UNITED STATES PATENT AND TRADEMARK OFFICE

APPLICATION NO.	FILING DATE	FIRST NAMED INVENTOR	ATTORNEY DOCKET NO.	CONFIRMATION NO.
10/587,367	04/26/2007	Dieter Ramsauer	135408-2036	8433

Office Action Summary	Application No. 10/587,367	Applicant(s) RAMSAUER, DIETER	
	Examiner KRISTINA R. FULTON	Art Unit 3673

DETAILED ACTION

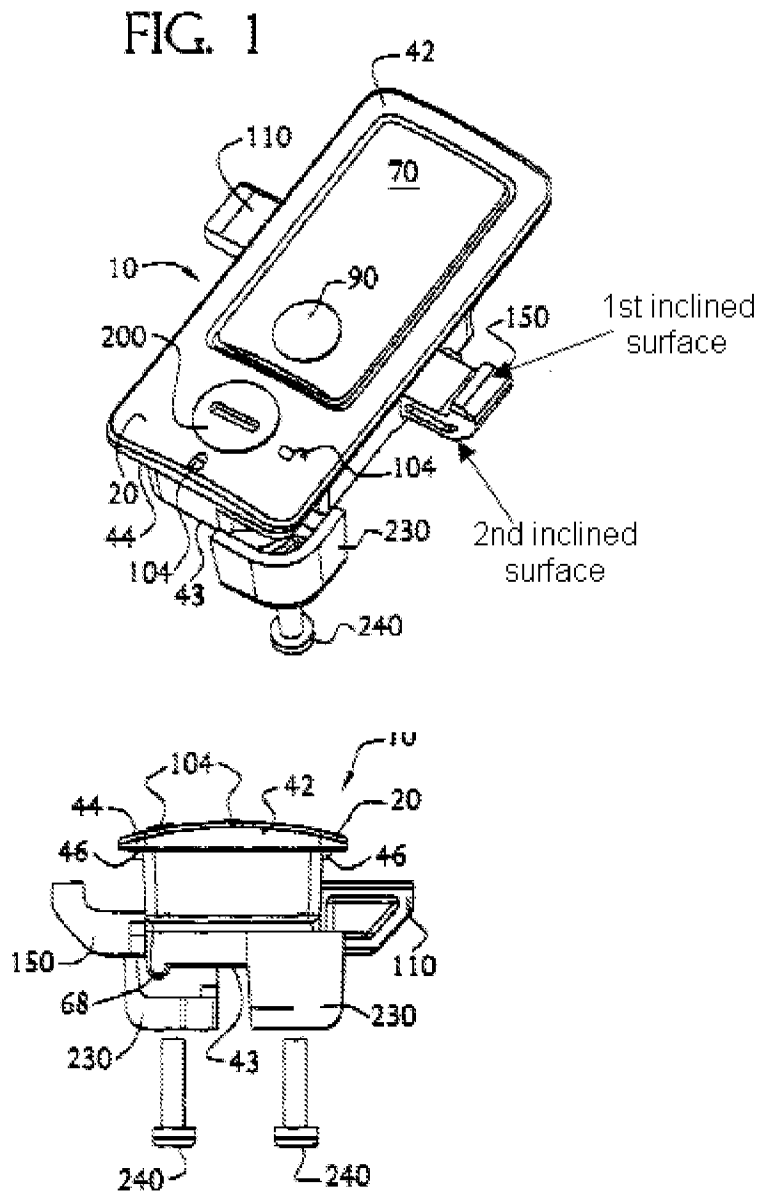
9. Regarding claims 23 and 26, Vickers teaches a latch having a head part (42) arranged outside a thin wall, a body part (20 below 42) which proceeds from the head part and projects through the opening in the mounted position, holding elements (110 and 150) which project from the body part and are flexible in a direction, a free end of the holding elements being provided with an inclined surface (see figure 3), the body part and the holding elements being separate parts and the holding elements being slides. Please note "as best understood" for the last limitation of claims 28 and 31 and claim 34, Vickers shows a lock cylinder (200) associated with holding elements (110 and 150). As best understood, Vickers shows the slides are held against a pressure spring force (198) by a hook arrangement (tabs and slots seen in figures 9 and 10). Vickers further shows first and second inclined surfaces as shown below.
